EO 40-5-5A

ROYAL CANADIAN AIR FORCE

# LIST OF SPECIAL INFORMATION

## BATTERIES - GENERAL

Figure 1

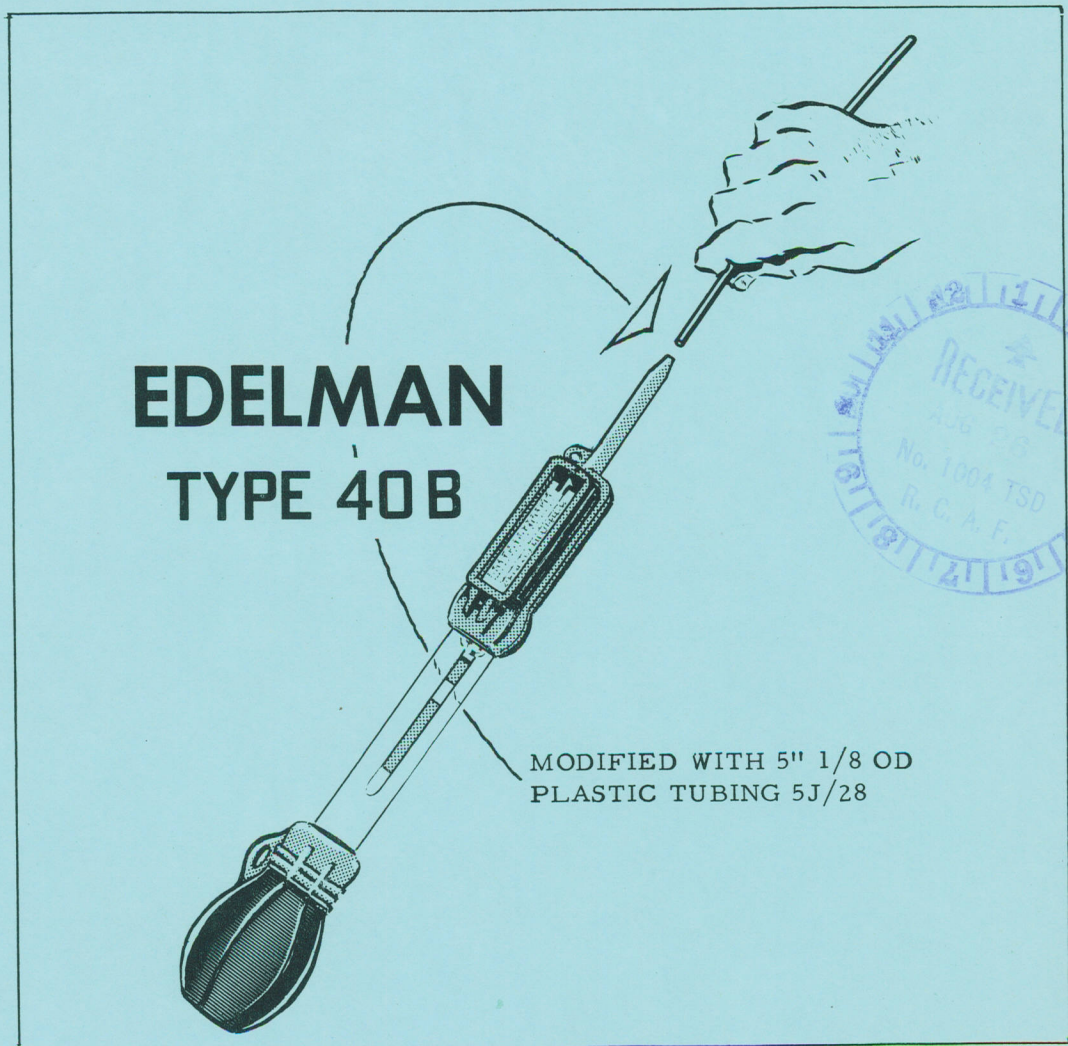
1 The present battery hydrometer RCAF Ref. 5J/28 has been found unsatisfactory in the testing of AR12-25 and AR12-36 Willard batteries. These batteries have smaller diameter filler wells which prevent the Edelman 40B type hydrometer from being used. To obviate this condition a 5" piece of tubing can be inserted into the hydrometer tip to facilitate the testing of these batteries.

2 A 5" piece of 1/8" diameter plastic, hard rubber or bakelite tubing or the plastic covering from line communication wire RCAF Ref. 5E/404 may be used for this installation, see Figure 1 for a general view.

Figure 1

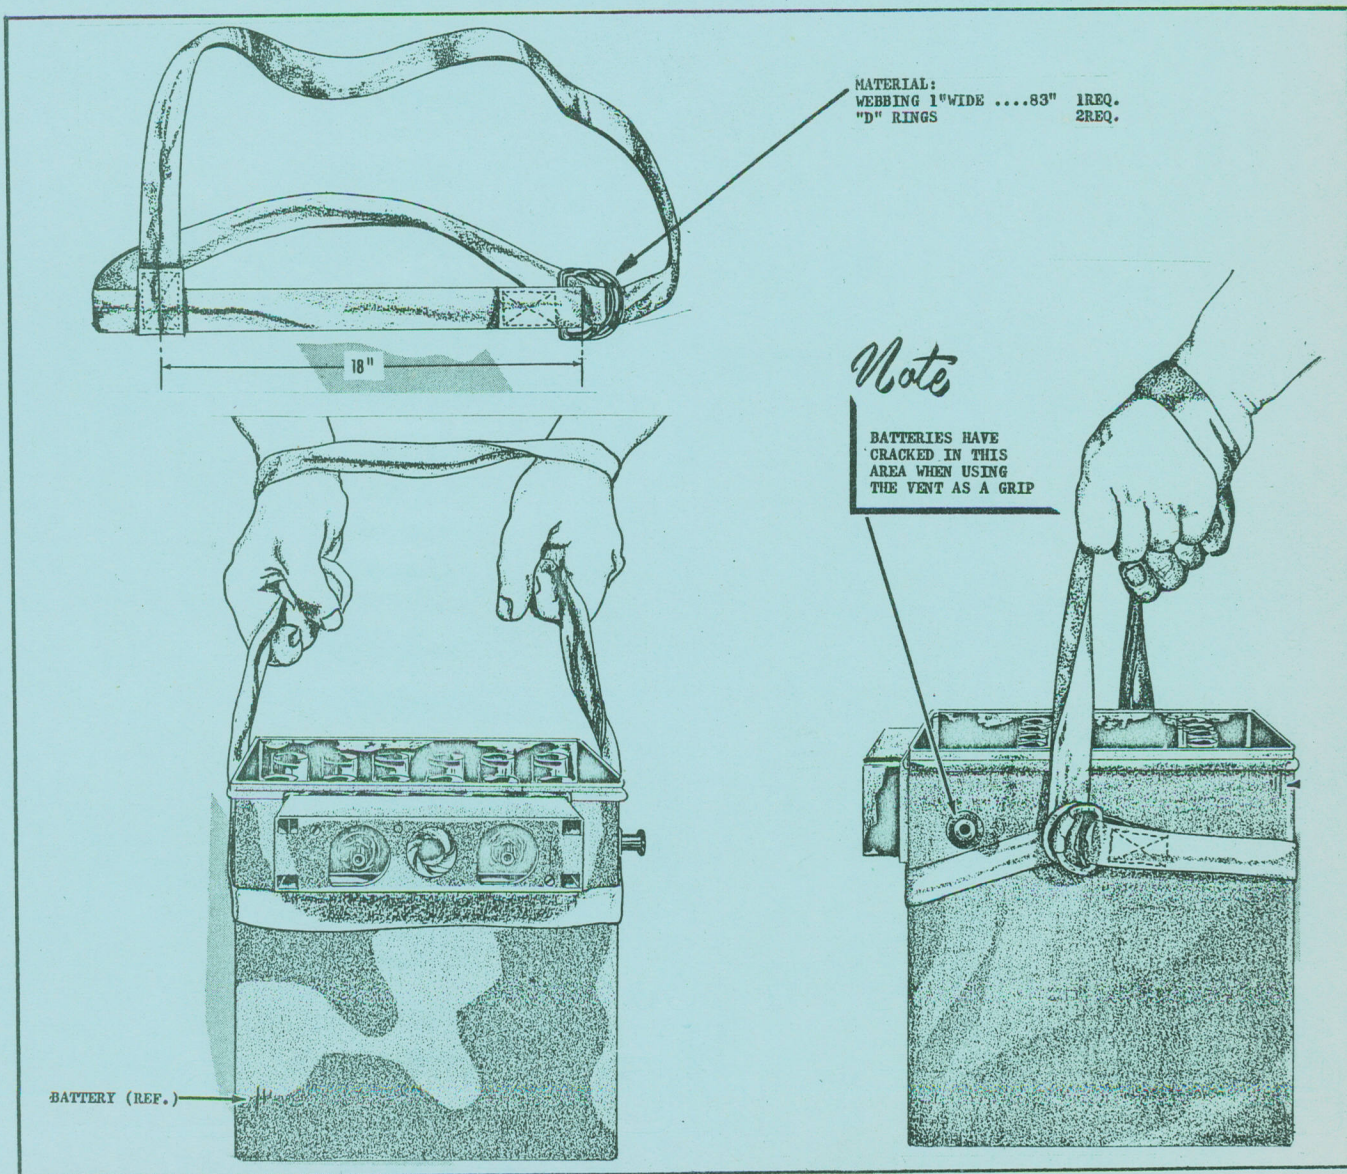
1 It has been reported that aircraft batteries RCAF Ref. 5J/174 have been found leaking near or around the battery vent. It is believed that failure of the battery in this area may be attributed to using the battery vent as a hand grip when removing or installing the batteries in aircraft.

2 A sling has been proposed as outlined in Figure 1 which will facilitate removal and installation of the battery. The sling may be manufactured locally on an as required basis.

Figure 1

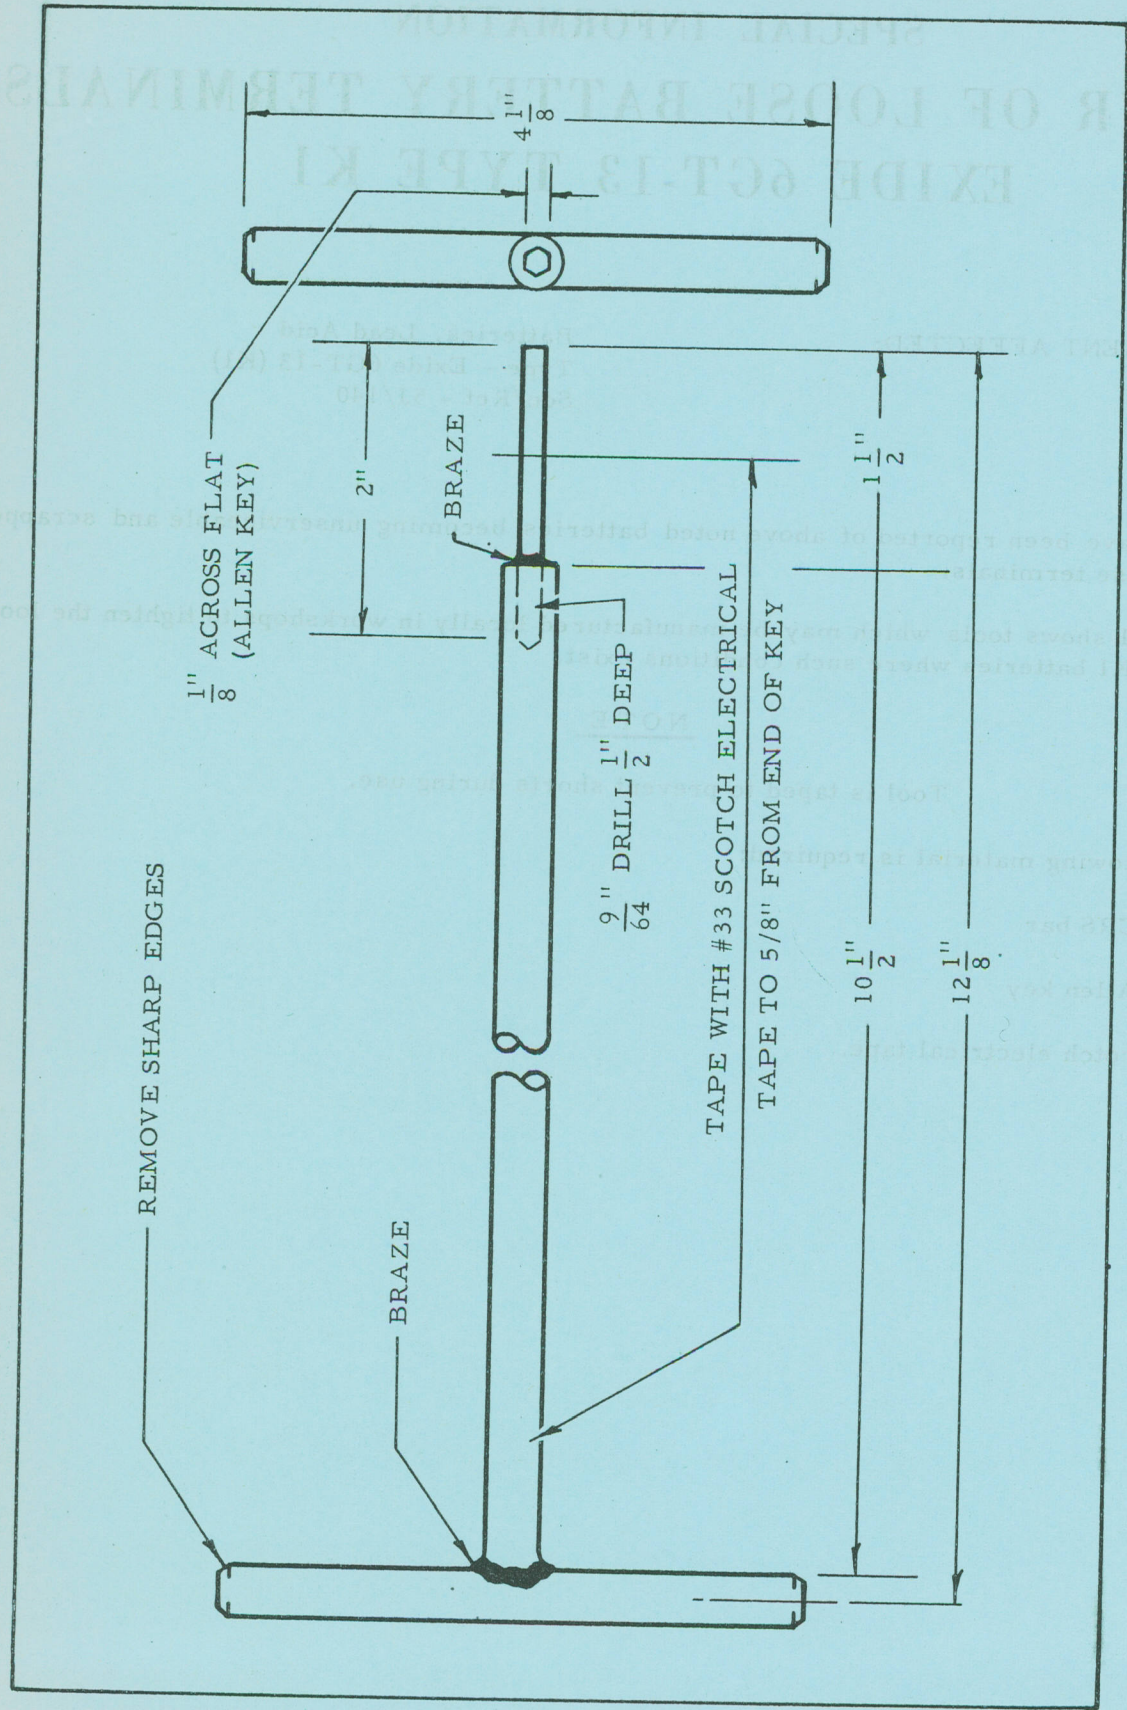
1 Cases have been reported of above noted batteries becoming unserviceable and scrapped because of loose terminals.

2 Figure 1 shows tools which may be manufactured locally in workshops to tighten the loose terminals on K1 batteries where such conditions exist.

Tool is taped to prevent shorts during use.

- (a) 1/4" CRS bar
- (b) 1/8" Allen key
- (c) #33 Scotch electrical tape.
